ADDENDUM NO. 1

TO: PLANS AND SPECIFICATIONS FOR STATE OF MISSOURI

**Sewer and Water Line Improvements
Weston Bend State Park
Weston, Missouri
Project No. X2322-03**

Bid Opening Date: 1:30 PM, Tuesday, October 15, 2024 (Not Changed)

C-104

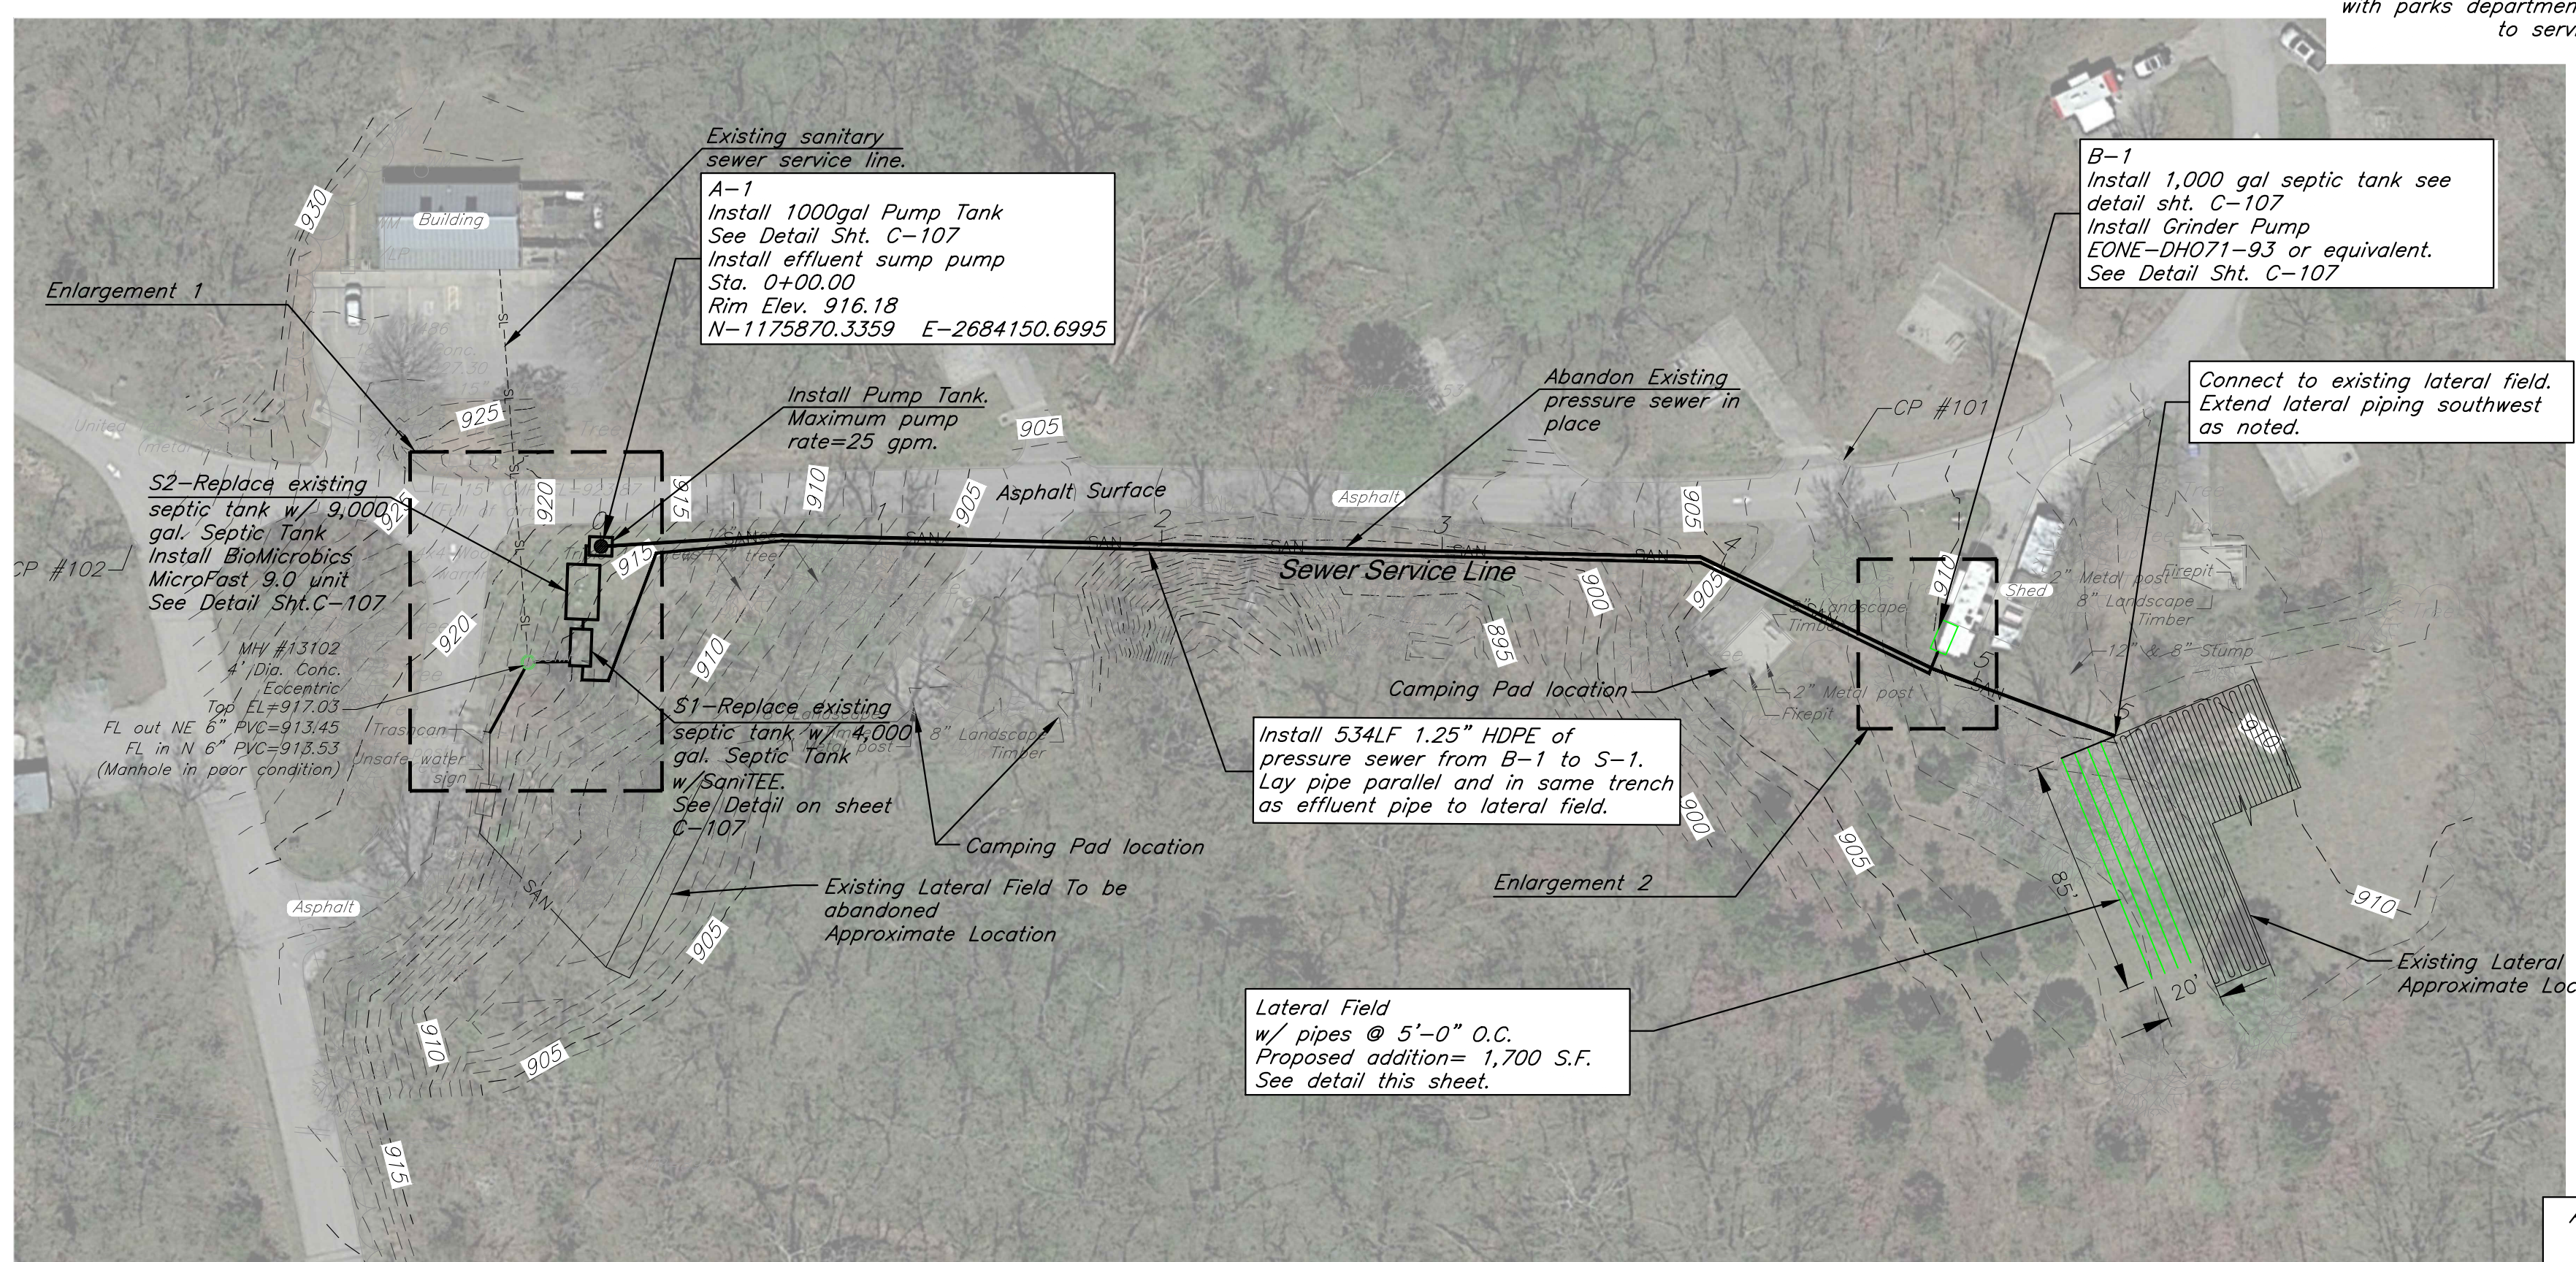
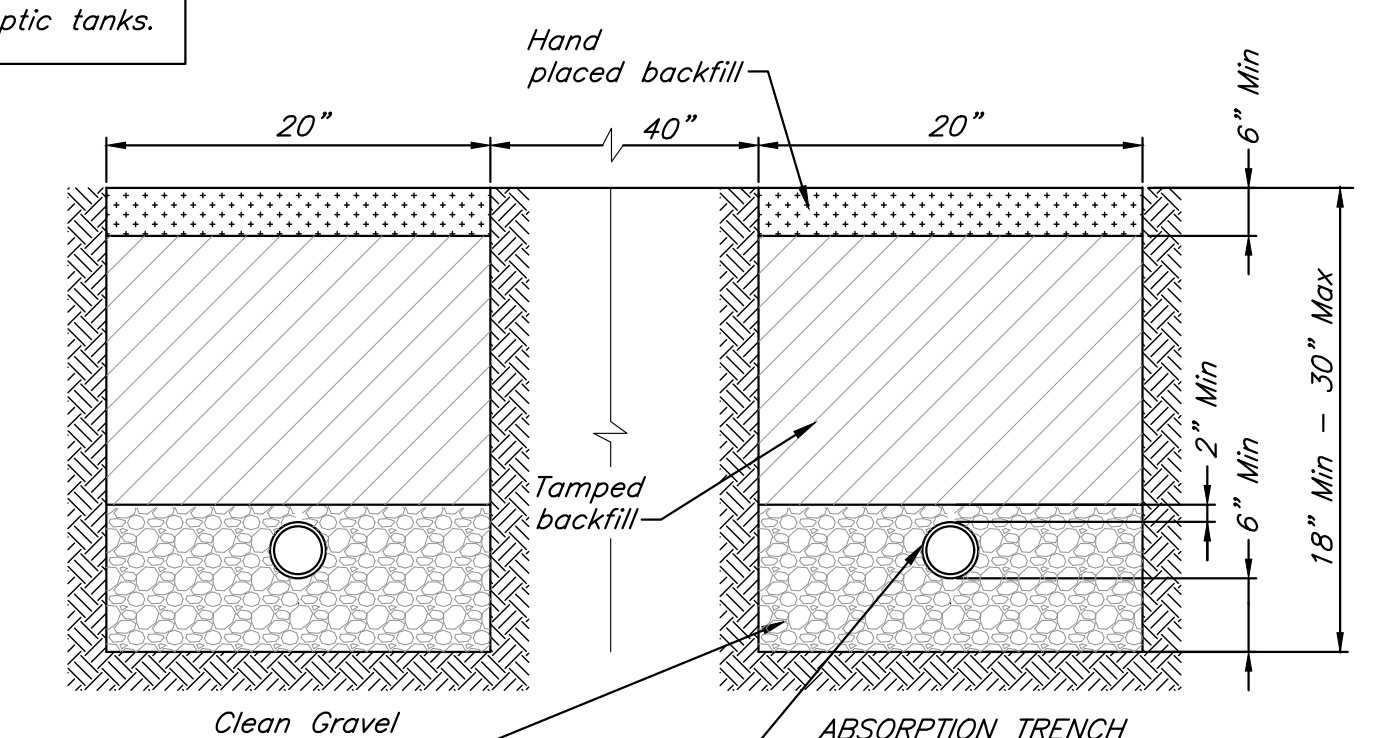
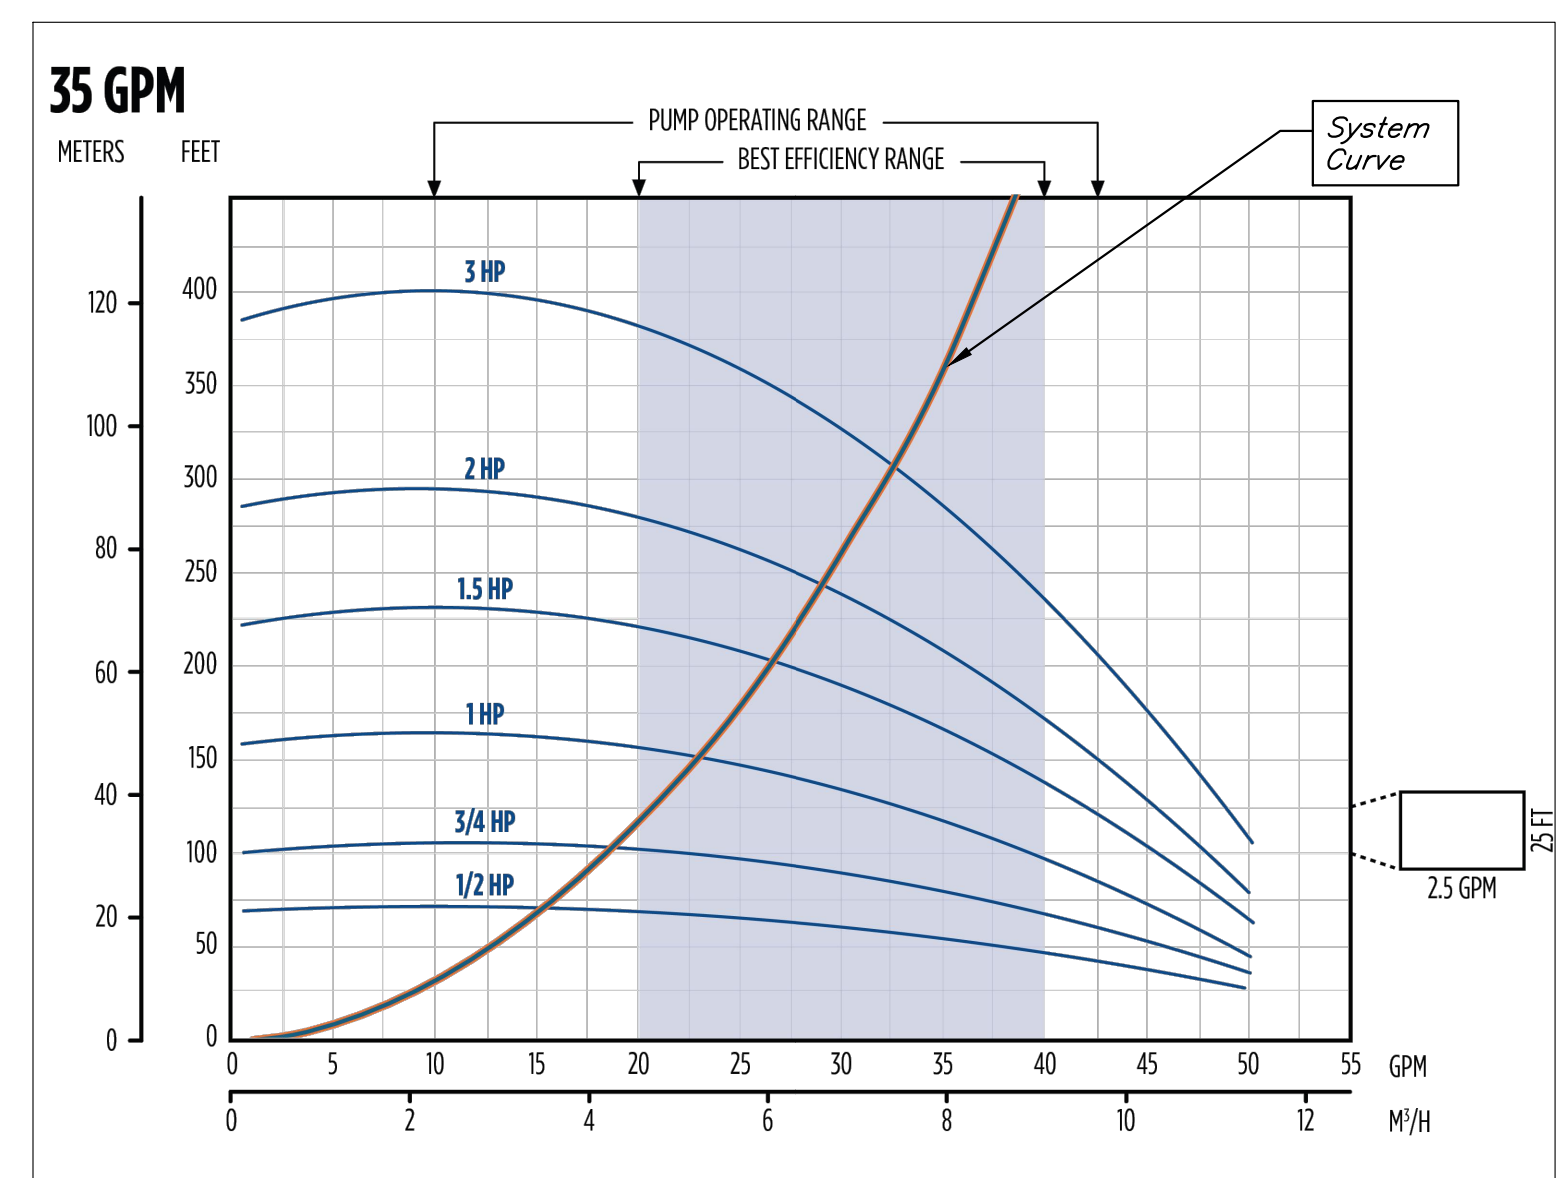
1. Sheet C-104
 - a. Add designation for septic and pump tanks.
 - b. Change MicroFAST 3.0 to MicroFAST 9.0 or equal AND increase size of tank S2 to 9,000 gal.

- c. Revise note for first tank (S1): "Replace existing septic tank w/ 4,000 gal. Septic Tank"
 - d. Remove Manhole A-2 and Host site connection. Replace with grinder pump and 1000 gal. pump tank. Add service line to Septic tank S-1

- e. Add enlargement 2 – Blow up of Grinder Pump servicing camp host site.
 - f. Add pump curve for effluent pump A-1 (pump to lateral field)
 - g. Add 535 LF of 1.25" HDPE line from camp host site to septic tank S1 (First septic tank).

- h. Add Lateral Field Detail to sheet.
 - i. Revise pump sizing calculation requirements. Add Pump Sizing calculations for Pump B-1.
 - j. Change profile effluent pipe size from 1" HDPE to 1.25" HDPE.

- k. Add note for secondary power connection: "A secondary power connection with power transfer switch for emergency power outages shall be provide for the A-1 and S-2 systems. Secondary connection is anticipated small portable gas/diesel generator. Generator shall provide power for entire system: Pumps, blowers, alarms, and another apparatus. Anticipated generator size is 2.5KW."

- l. See attached revised sheet for revisions.
2. Sheet C-105
 - a. ADD the following Note: "Install gate valves on main service line every 1,00 feet and at Tee connections."

- A-1 Pump Sizing**
- Static Head = -5 FT
 - Friction Loss = 553.3 FT of 1.25" HDPE at 25 gpm = 177.5 FT
Total = 178 FT
 - Total Dynamic Head = -5 + 178 = 173 FT
 - Pump Requirements: 25 gpm and 173 FT TDH

- B-1 Pump Sizing**
- Static Head = 5 FT
 - Friction Loss = 535 FT of 1.25" HDPE at 13 gpm = 47.6 FT
Total = 48 FT
 - Total Dynamic Head = 5 + 47 = 53 FT
 - Pump Requirements: 13 gpm and 53 FT TDH

A secondary power connection with power transfer switch for emergency power outages shall be provide for the A-1 and S-2 systems. Secondary connection is anticipated small portable gas/diesel generator. Generator shall provide power for entire system: Pumps, blowers, alarms, and another apparatus. Anticipated generator size is 2.5KW

- REQUIREMENTS**
- Minimum area of 1,700 ft².
 - 340 LF of dispersal tubing placed 5 ft. O.C.
 - 4 Lengths at 85'.
 - Dispersal tubing shall be installed at 24" below finished grade. See Detail this sheet.
 - Contractor to pump out and remove existing septic tanks.
